CALIFORNIA COASTAL COMMISSION
CENTRAL COAST DISTRICT OFFICE
725 FRONT STREET, SUITE 300
SANTA CRUZ, CA 95060
(831) 427-4863

COASTAL DEVELOPMENT PERMIT APPLICATION

Application number.....**3-03-016, Lang Revetment Maintenance**

Project description.....Recognize emergency rip-rap revetment repair work from winter 2002-3, and provide for future maintenance work on a previously permitted, approximately 280 linear foot revetment.

ROCK RIPRAP SHORE PROTECTION
MAINTENANCE PLAN
FOR LANG RESIDENCE

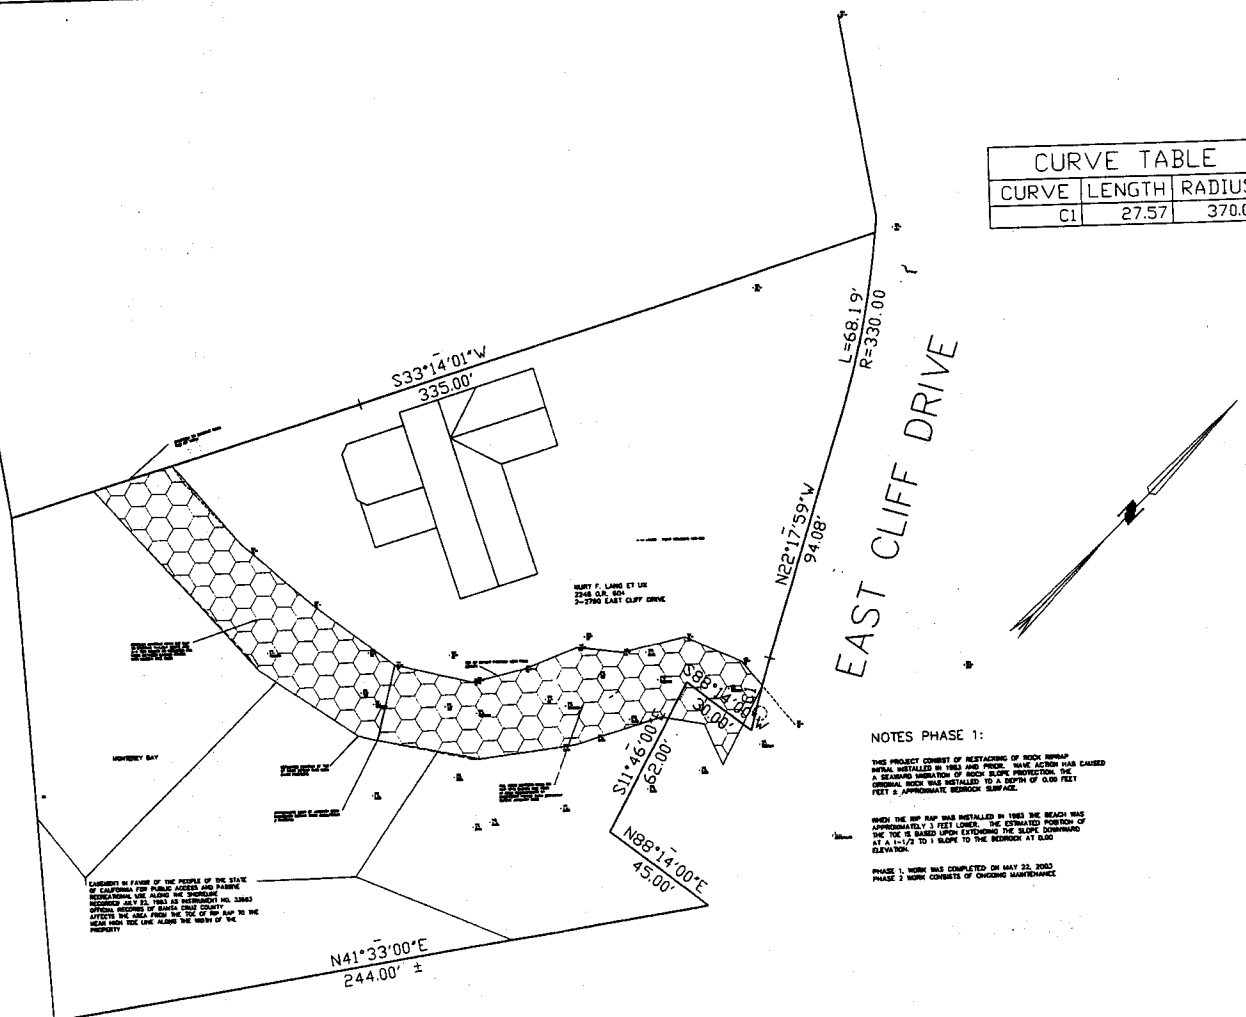
(d) Construction Notes. That portion of the plans that refer to future maintenance and construction parameters (i.e., that section of Sheet 1 titled "Maintenance Program") shall be replaced with the Construction Plan specified in Special Condition 2 below and the future maintenance parameters noted in Special Condition 12.
